City of Milwaukee Historic Preservation Staff

2518 N. Terrace Ave. Milwaukee, WI 53211

APPROVED By Tim Askin - Milwaukee HPC at 10:27 am, Feb 20, 2020

SHEET TITLE Exterior Elevations

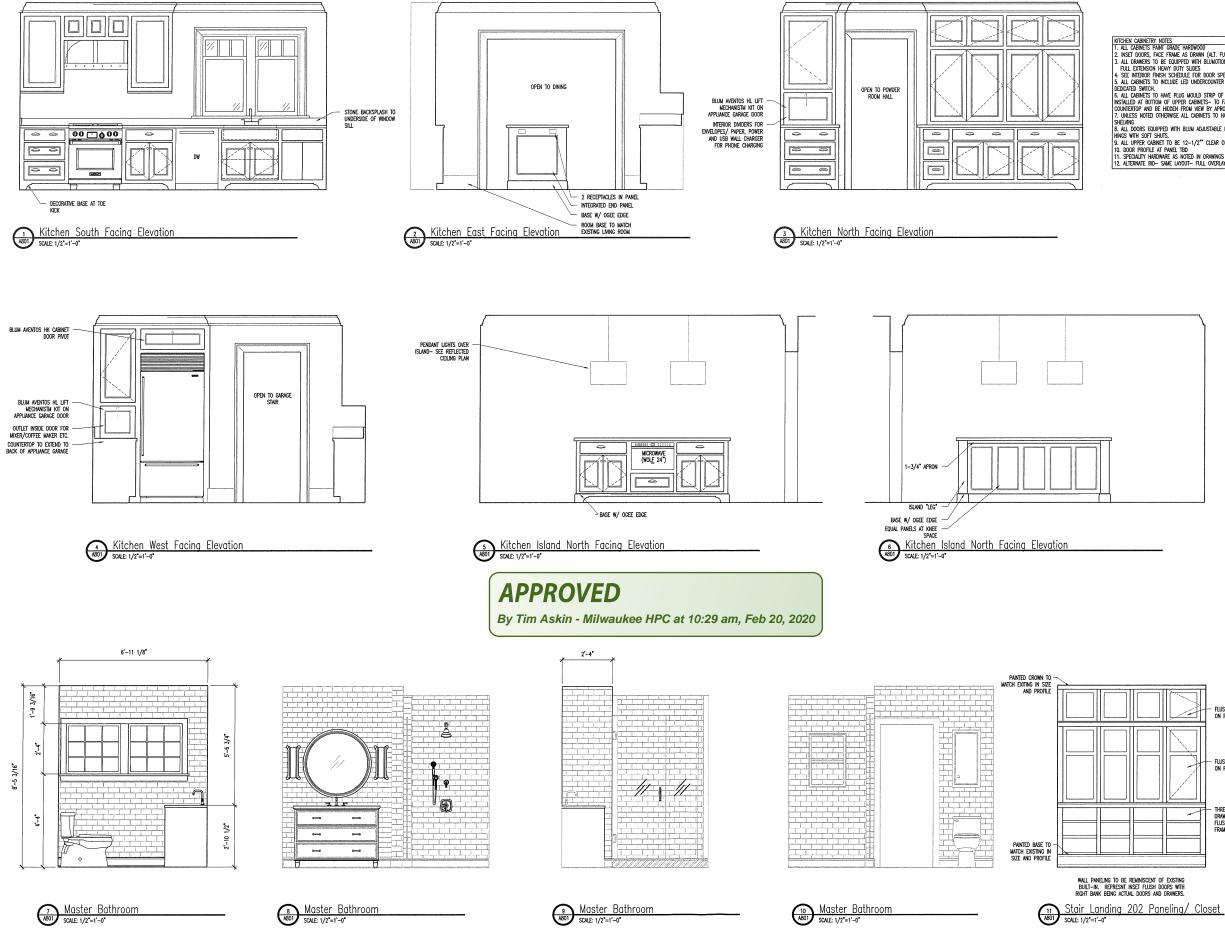
and the sill shortened and reused and shortened to match the replacement

window width..
